PLANNING BOARD REPORT
PORTLAND, MAINE
208 Fore Street
New Construction
Level III Subdivision / Site Plan and Conditional Use
PL-000153-2018
Applicant: Flagg Partners, LLC.

Submitted to Portland Planning Board Public Hearing Date: August 14, 2018	Prepared by: Christian Roadman Date: August 10, 2018
--	---

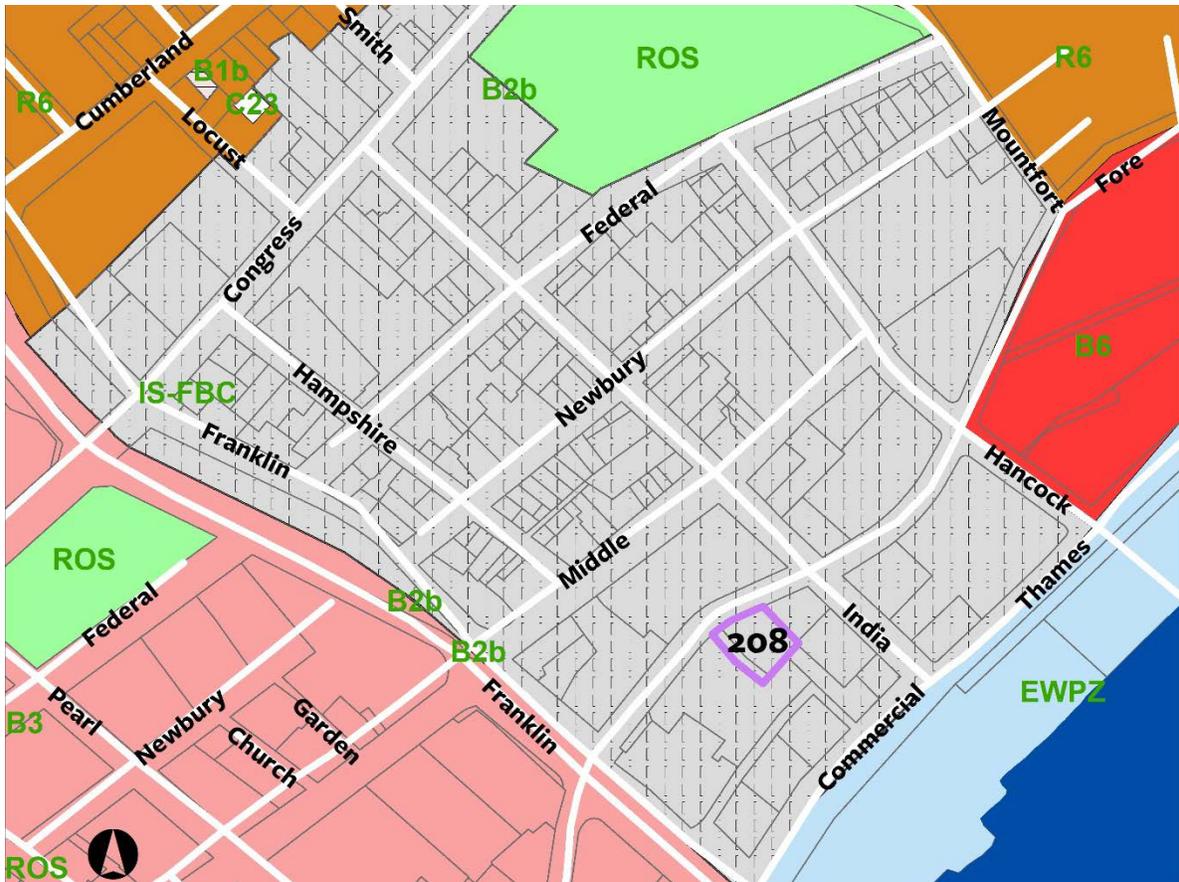
The proposed project falls under the zone's Urban Transitional (UT) subdistrict, and appears to meet its siting standards, frontage requirements, and building entry requirements. However, one set of balconies on the western side of the building appears to overhang the 10 foot side setback more than the two foot maximum.

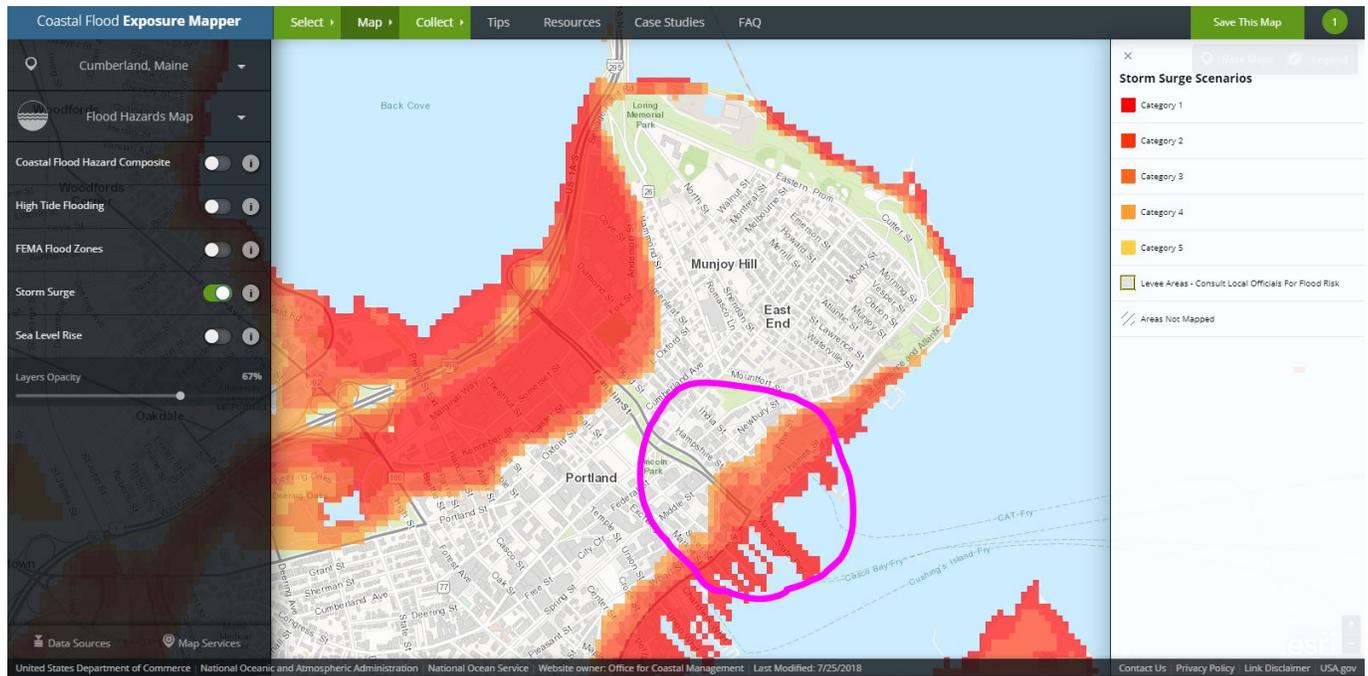
Bruce Hyman, the City’s Transportation Program Manager, expressed that the sidewalk should be widened along the proposed project to create a seven foot wide sidewalk (attachment 1). This will result in a curb-to-curb width of 31 feet on Fore Street, allowing for on-street parking on the opposite side. Please note the public comment regarding sidewalk width (attachment PL-1) mentioned above.
